UNITED STATES PATENT AND TRADEMARK OFFICE

10/824,229

Office Action Summary

DETAILED ACTION

FIG. 1.

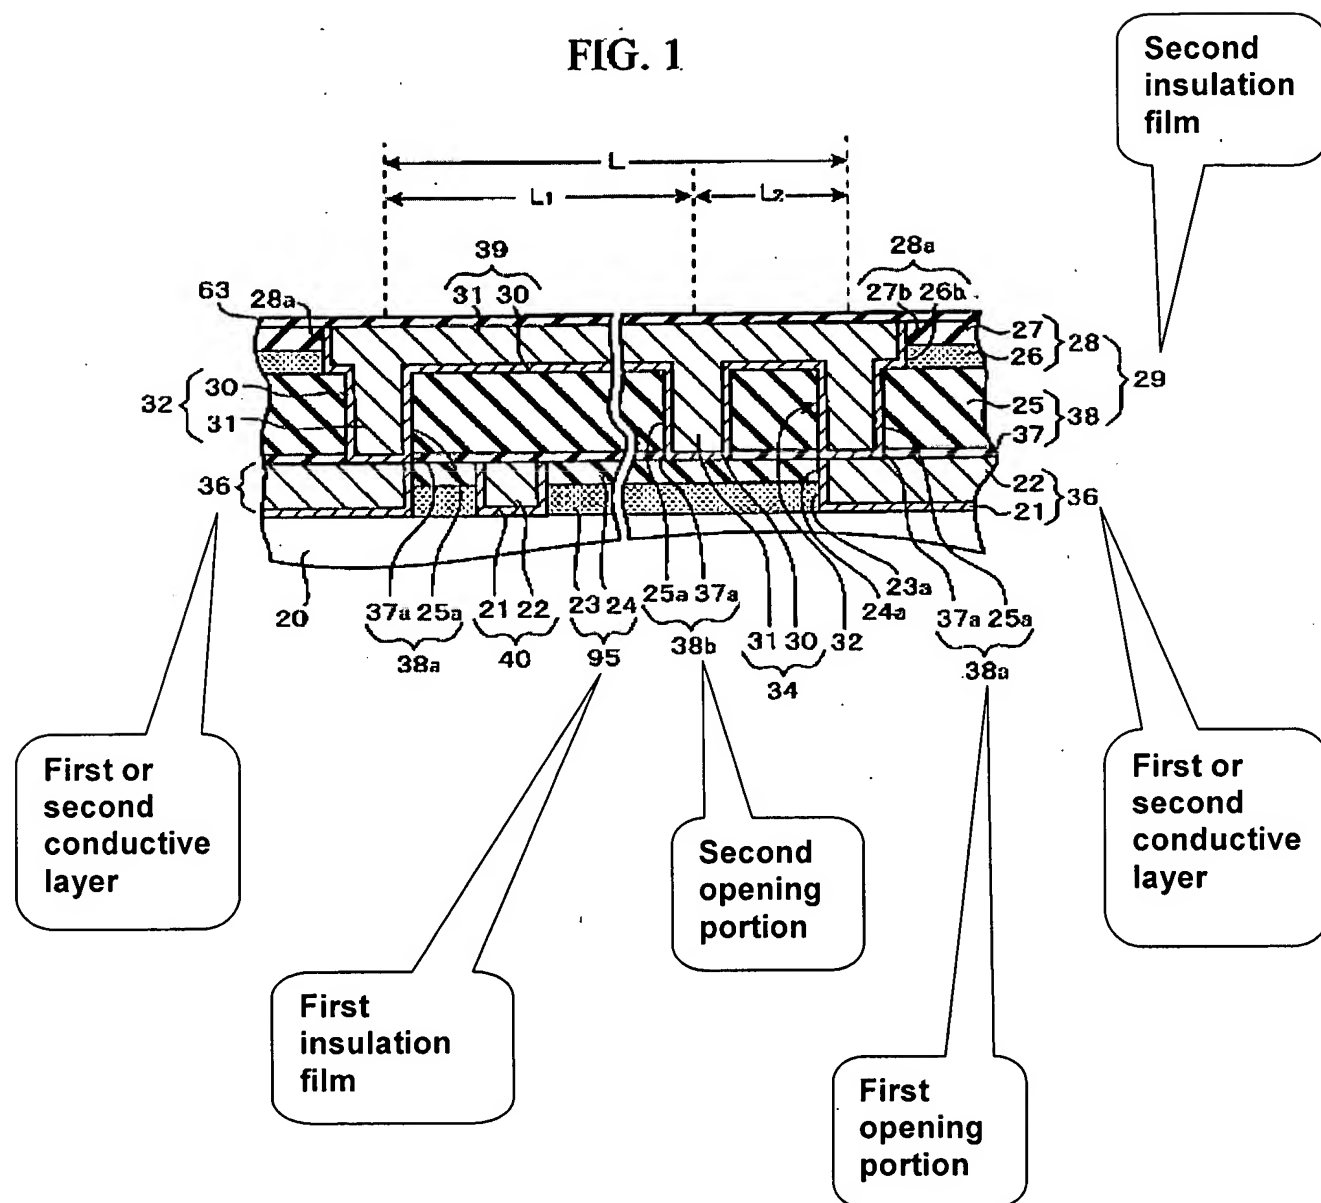
However, Watanabe (Fig. 1) discloses a semiconductor device comprising: a first insulation film 95 formed on the substrate 20 (paragraph [0061], lines 6-11); a first conductive layer 36 formed on the substrate 20 (See Fig. 1 Labeled by Examiner below and paragraph [0064], lines 2-4); a second conductive layer 36 formed on the substrate 20 (paragraph [0064], lines 2-4); a second insulation film 29 (paragraph [0066]) formed on upper surfaces of the first and second conductive layers 36 and having a plurality of first opening portions (28a,38a) (paragraph [0067], lines 1-2) to expose either the first conductive layer 36 or the second conductive layer 36 and one or more second opening portions 38b to expose neither the first conductive layer nor second conductive layer 36

and expose the first insulating film 95; and a third conductive layer 31 (paragraph [0068], lines 7-8) formed on an upper surface of the second insulation film 29 in such a manner to fill up the first opening portions (28a,38a) and the second opening portions 38b for making electrical connection between the first and second conductive layer 36 by way of the first opening portions (28a,38a); wherein the second opening portions 38b are formed between a pair of the first opening portions (28a,38a) along the third conductive layer 31 (See Fig. 1 Labeled by the Examiner below) in order to provide a semiconductor device whose stress migration resistance (paragraph [0018]).

Accordingly, it would have been obvious to modify the device of APA by forming one or more second opening portions to expose the first insulating film because such a forming one or more second opening portions to expose the first insulating film would provide a semiconductor device whose stress migration resistance, as taught by Watanabe (paragraph [0018]).

Regarding claim 2, as discussed above, Watanabe further discloses that the second opening portions 38b are formed at a predetermined distance between the first opening portions (28a,38a).
